工程指示 / 要求簡箋(E.I.)

工程名稱：觀塘裕民坊

工程項目：上廠跟進事項(2019年10月份)

Factory Inspection Report 12

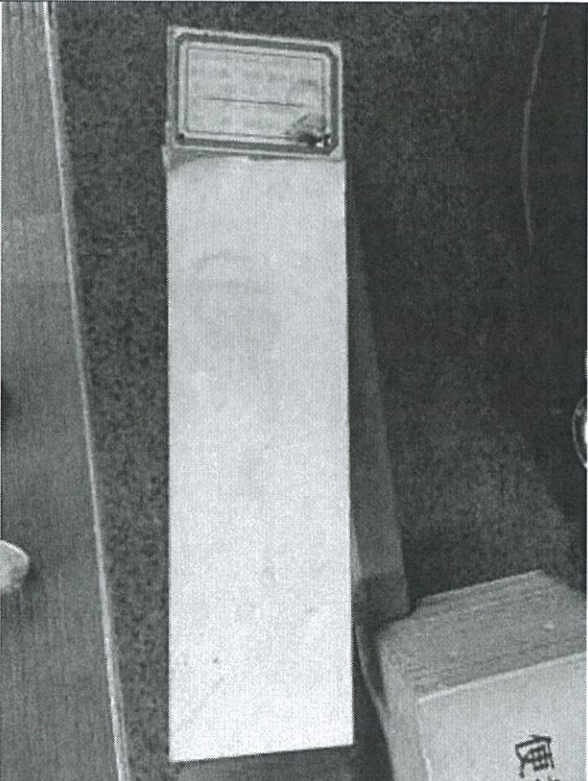
Photo 13	
<u>Item:</u> Installation environment	
<u>Description:</u> The doors of SSG room were found always open, possibly affecting the conditions such as temperature, humidity, and cleanliness. Contamination to the glazing process may appear.	
<u>Action:</u> Midi is required to keep the doors closed.

打膠房門必須保持關閉，房內溫度及濕度以及避免灰塵進入房內，影響打膠效果
建議增加門鎖，以防忘記關門
